Centennial Hills Hospital, Update for Phase 2

CITY OF LAS VEGAS		DATE:
INTER-OFFICE MEMORANDUM		December 21, 2016
TO: Land Development Services Department of Building & Safety		FROM: Albert Sung, P.E. Flood Control Project Engineer Department of Public Works
SUBJECT:	Drainage Study for:	
	Centennial Hills Hospital – Update for Phase 2 Parking Lot Expansion	
Cross Streets:	NEC of Durango Drive & Deer Springs Way	COPIES TO:
File Number:	F:\Depot\DSMemos\DS4853A.doc	MHP Limited, LLC
Parcel Number:	125-20-610-004	Valley Health System, LLC
Zoning Action:	SDR-xxxxx	Bart Anderson, P.E., DevCo
FEMA Flood Zone	YES	NO X
Proposed Storm Drain	YES	NO X

RE: Update #2 for Technical Drainage Study for Centennial Hills Hospital (CLV DS #3822).

Worksheet for Prop. Depress Curb Section

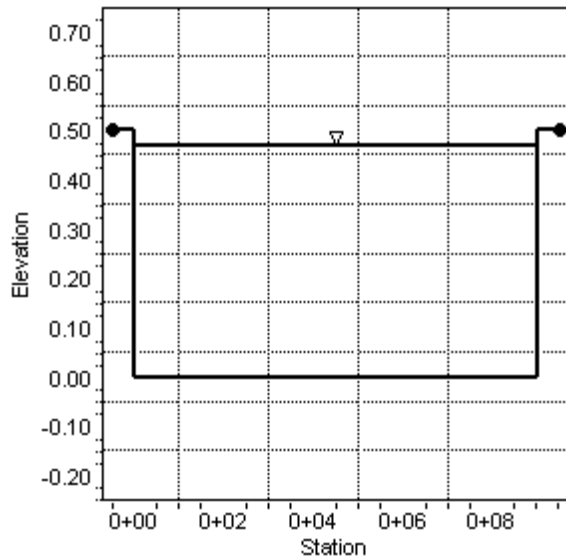
3. **Construction Note #5** called for a 5'-wide depressed curb. However, hydraulic calculation provided in the last submittal shows that the depressed curb is 9'-wide. Review and revise accordingly.

SHEET	GR
4 OF 5	DRAWING NO.

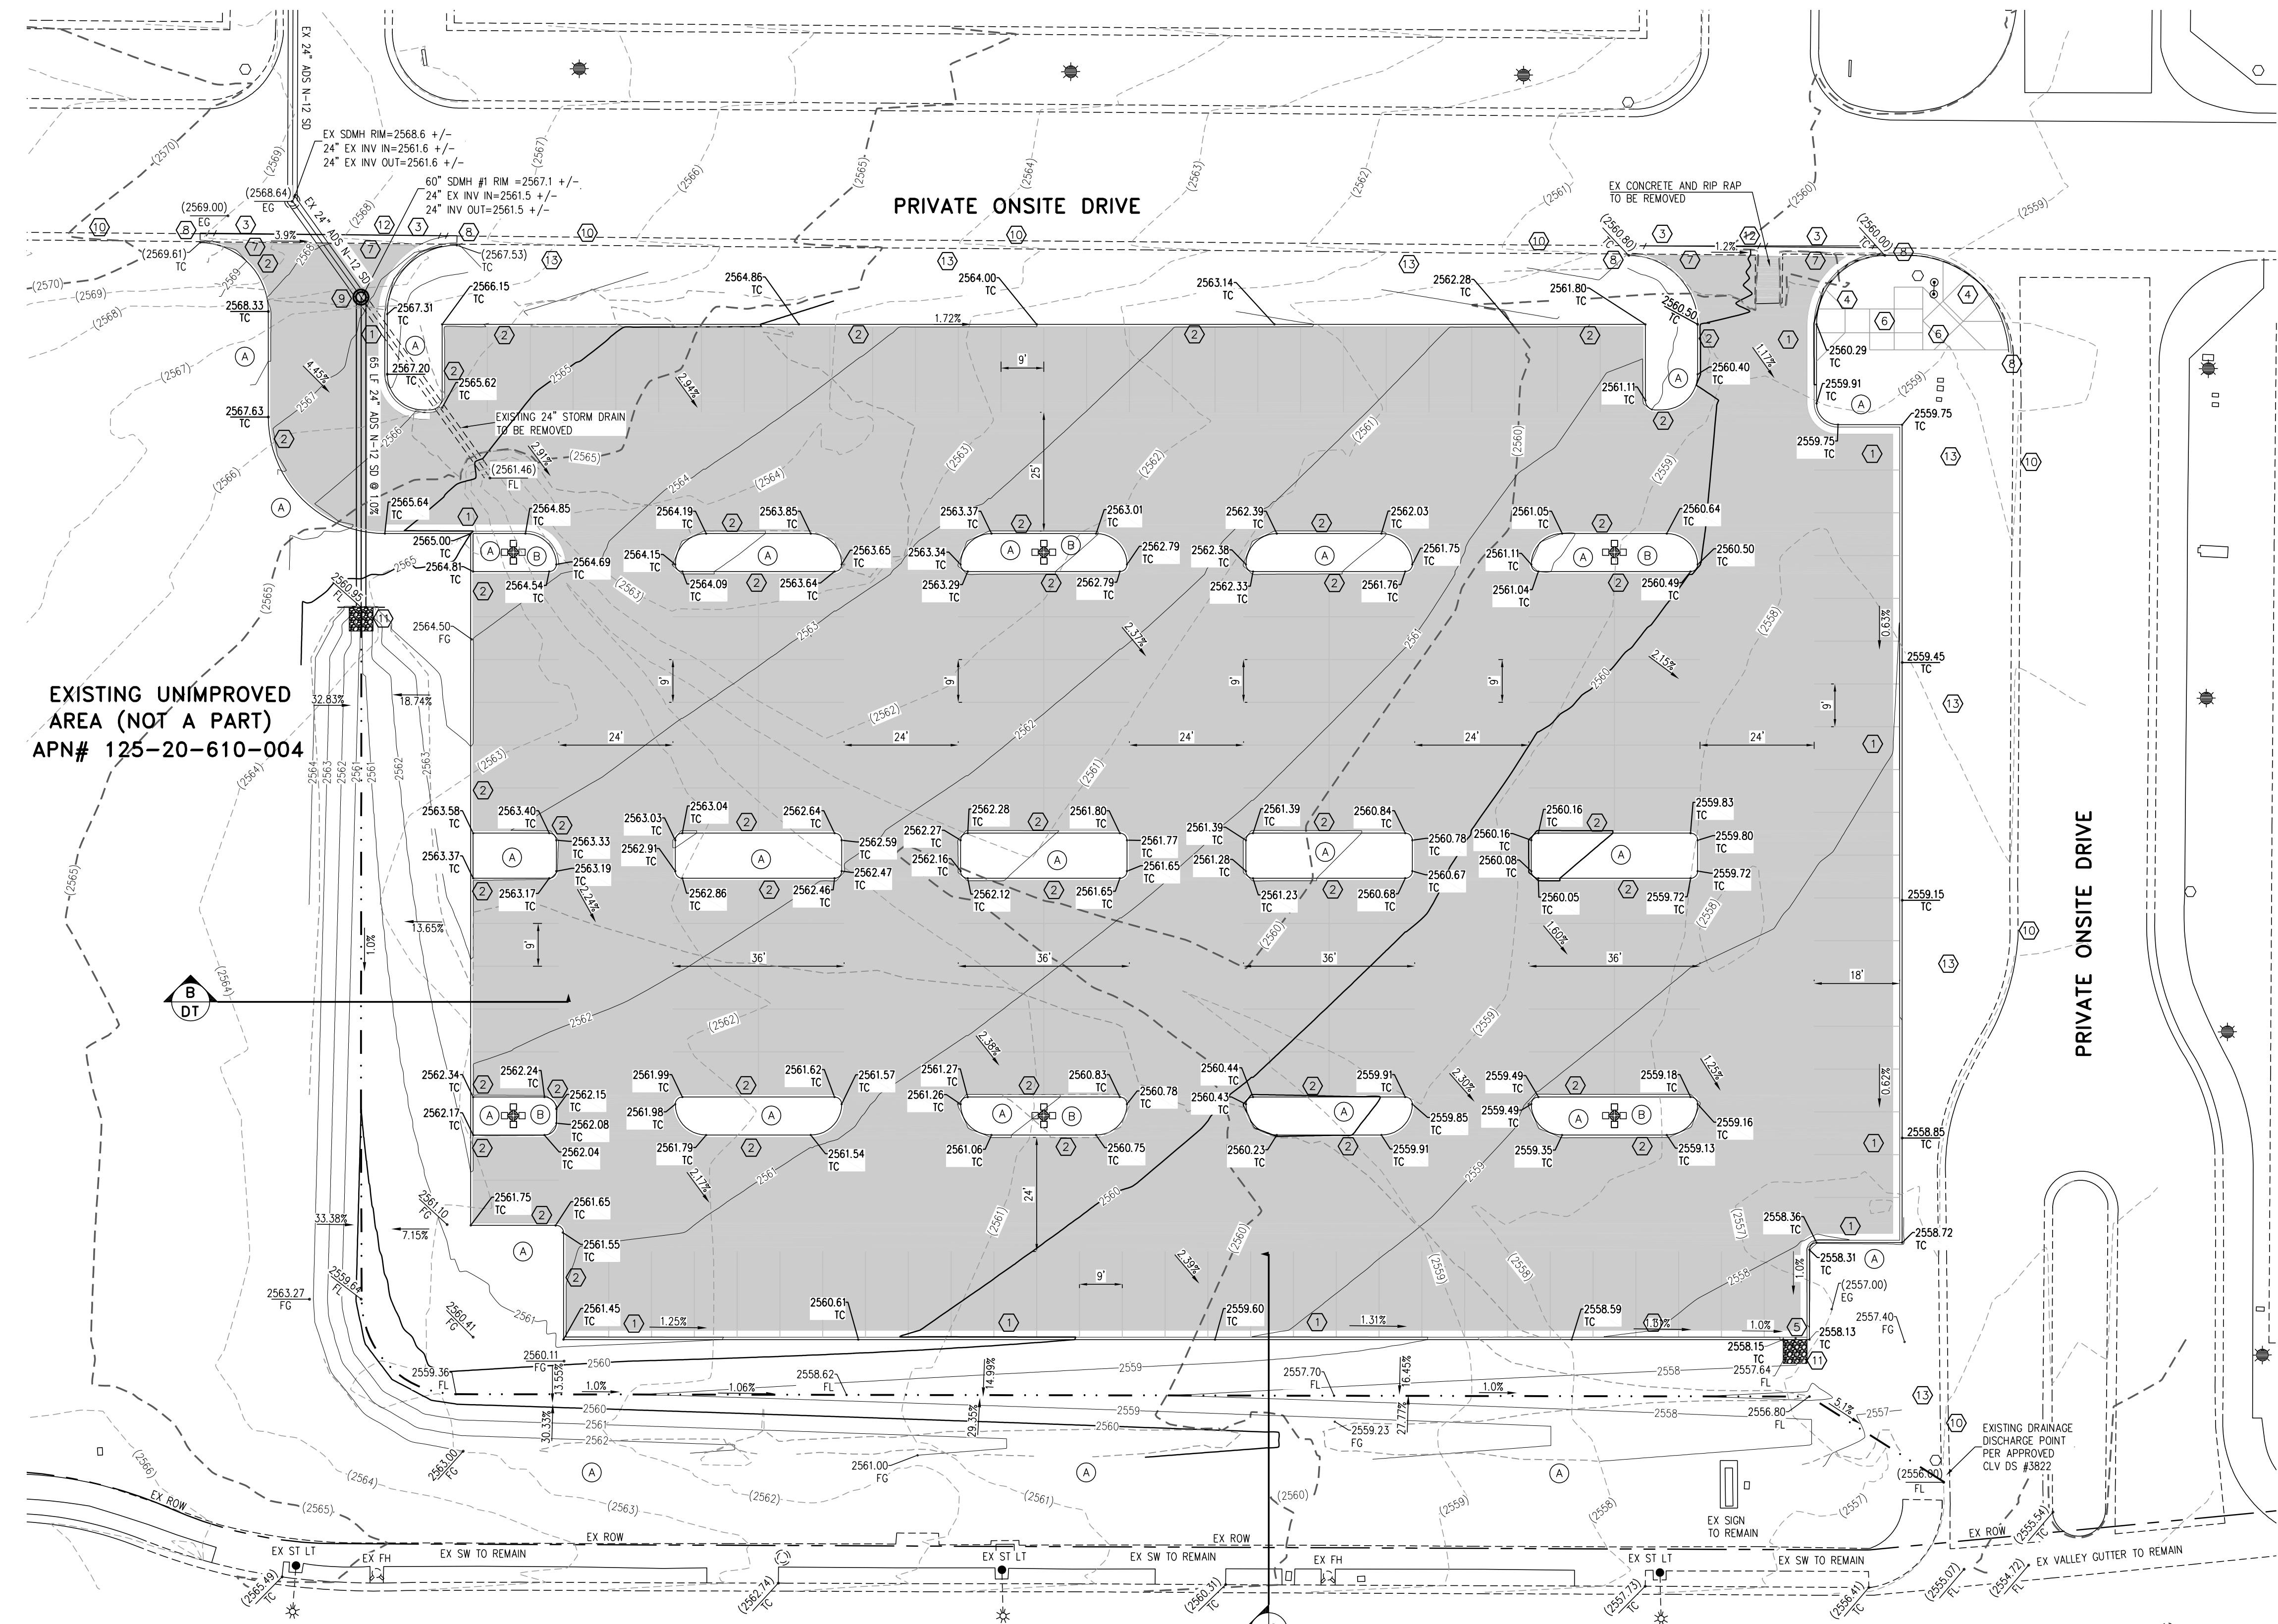
4. Provide a note on the grading plan: " All Onsite Storm Drains and the associated facilities are Privately Owned and to be Privately Maintained".
5. Add a note in all pertinent sheets for the construction of all storm drain drop inlets per a newly adopted USDCCA Drawing No. 421 (*Stormwater Quality Management Stamp and Sign Detail*).
